TECHNICAL SERVICE BULLETIN			
DATE ISSUED	MODEL YEAR(S) AFFECTED	MODEL(S) AFFECTED	TSB #
1/30/08	2007-2008	All with Oasis Heat	331
	BRAND		Түре
AllICypressINorthern StarIScottsdaleIAll Star MEI	American StarIDutch StarIKountry StarIKing AireIVentanaI	Kountry Aire	All \Box $T T \Box$ $F W \Box$ $C A \Box$ $D P \blacksquare$ $D B \Box$
All Star ME I Ventana I Image: A conditioning & Heating Electrical Components Appliances & Accessories Exterior Components Cabinets & Furniture Interior Components Chassis Components Plumbing & Bath Components Construction Components Windows, Awnings, Vents, & Doors DESCRIPTION OF PROBLEM			
	RECOMMENDED	SOLUTION	
Oasis has issued a Technical Service Bulletin to address concerns of an Oasis heating system that exhibits High Fault Limits. This procedure changes the "cycling auquastat" to and updated version. Any questions regarding this TSB should be directed to Oasis at (604) 278-1272, or Toll Free at 1-800-755-1272. READ THE PROCEDURE THOROUGHLY AND COMPLETELY PRIOR TO BEGINNING DIAGNOSIS OR REPAIRS.

Heating Systems	November 13, 2007	Bulletin Identification No.: MTB-102-22
Release Type: Public		Standard Repair Time: 45 Minutes
Affected Model(s):	OASI

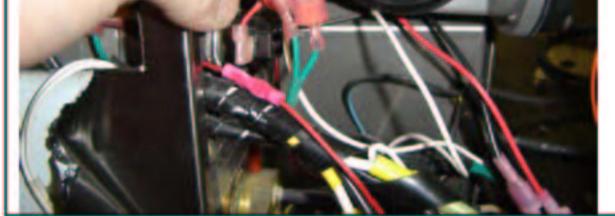
The cycling aquastat has been changed to a faster responding aquastat. If an Oasis, prior to this change, has had a problem with high limit faults, change the cycling aquastat by following the instructions below:

Slide the new aquastat bracket under the bottom square washer in position and tighten the bottom nut. Place a new nut on top and tighten down together with high limit aquastat tab.
Connect the green wires from the aquastat to the OASIS wiring harness. Place the front section back, close the aquastat cover and reconnect the 32-pin connector to the board. Turn on the power and check the operation
